FORM APPROVED
OMB NO. 1004-0137
Expires: January 31, 2018**SUNDRY NOTICES AND REPORTS ON WELLS**
*Do not use this form for proposals to drill or to re-enter an abandoned well. Use form 3160-3 (APD) for such proposals.*5. Lease Serial No.
NMLC063875A

7. If Unit or CA/Agreement, Name and/or No.
891000303X8. Well Name and No.
POKER LAKE UNIT 27 BD 161H9. API Well No.
30-015-46249-00-X110. Field and Pool or Exploratory Area
PURPLE SAGE-WOLFCAMP (GAS)11. County or Parish, State
EDDY COUNTY, NM**SUBMIT IN TRIPLICATE - Other instructions on page 2**

XTO Permian Operating, LLC. requests permission to make the following changes to the original APD:

DRILLING PLAN: BLM COMPLIANCE
(Supplement to BLM 3160-3)

13-3/8" x 9-5/8" x 5-1/2" 10M RSH-2 Wellhead
Assembly, With T-EBS-F Tubing Head

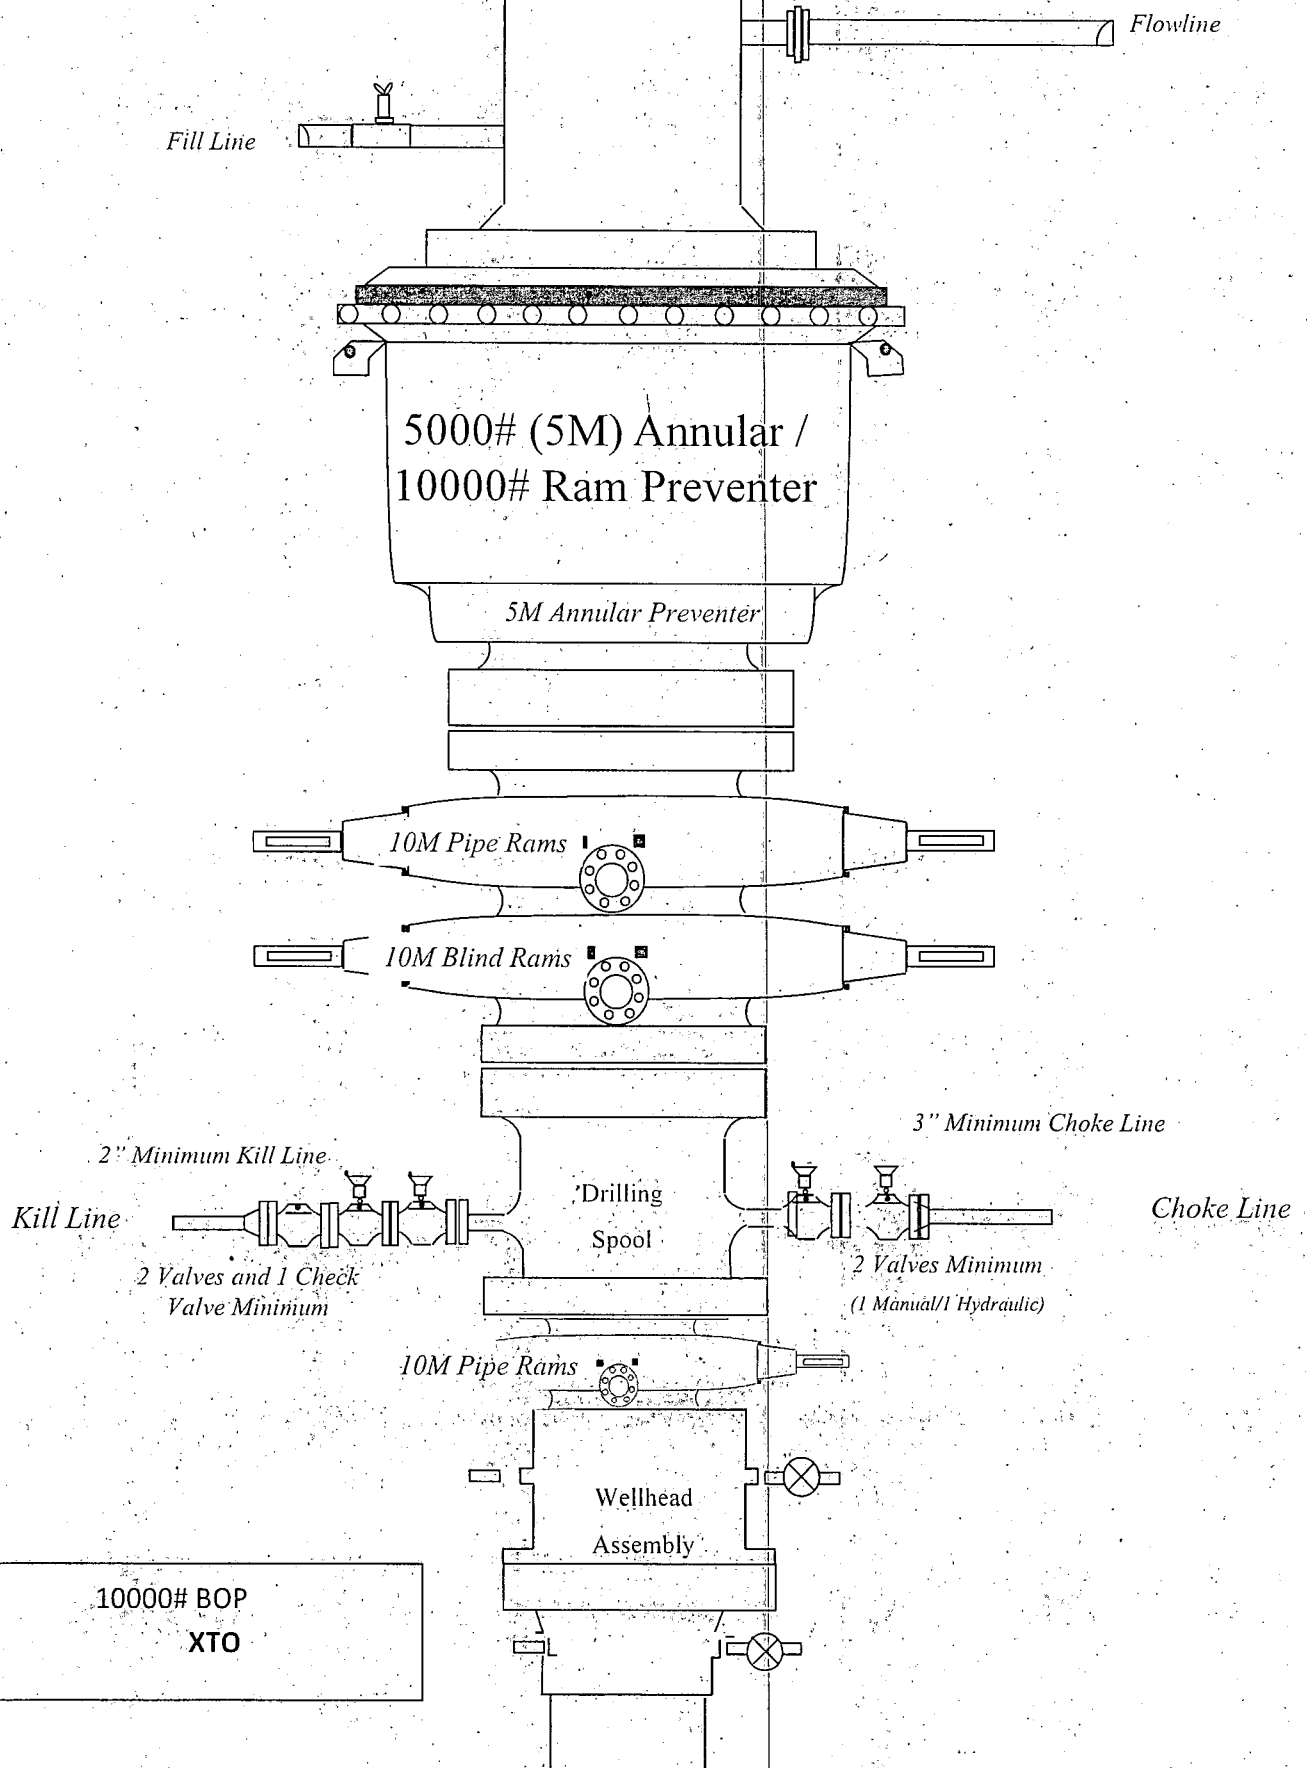
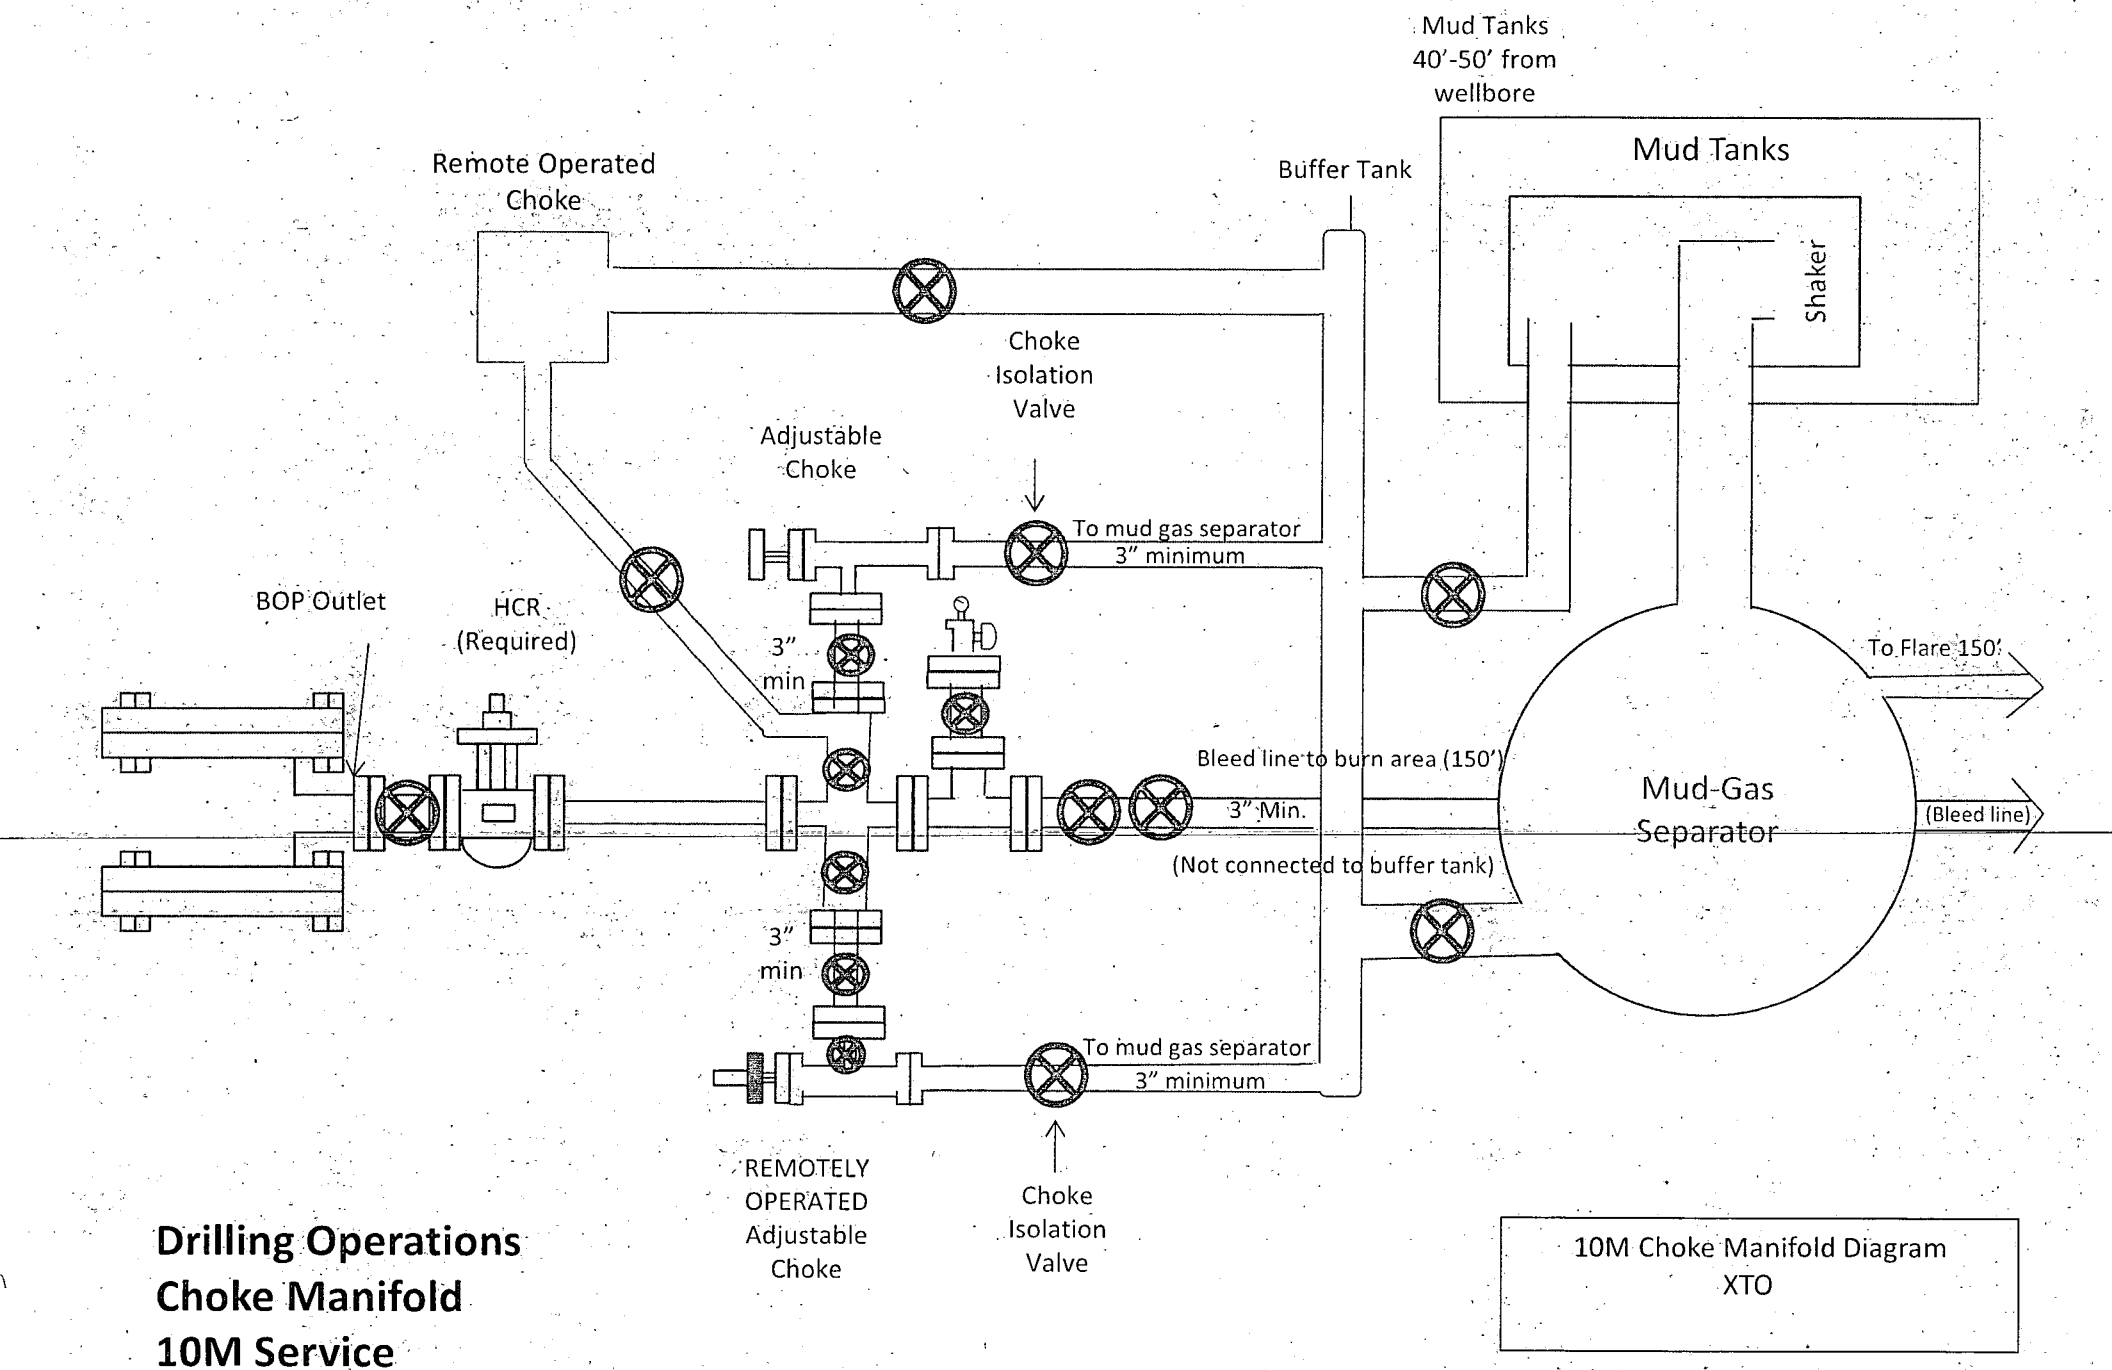
3. **Operator has proposed a multi-bowl wellhead assembly. This assembly will only be tested when installed on the surface casing. Minimum working pressure of the blowout preventer (BOP) and related equipment (BOPE) required for drilling below the surface casing shoe shall be 10,000 (10M) psi.**

- a. **Wellhead shall be installed by manufacturer's representatives, submit documentation with subsequent sundry.**
 - b. **If the welding is performed by a third party, the manufacturer's representative shall monitor the temperature to verify that it does not exceed the maximum temperature of the seal.**

- c. **Manufacturer representative shall install the test plug for the initial BOP test.**
 - d. **Operator shall perform the intermediate casing integrity test to 70% of the casing burst. This will test the multi-bowl seals.**

- e. **If the cement does not circulate and one inch operations would have been possible with a standard wellhead, the well head shall be cut off, cementing operations performed and another wellhead installed.**
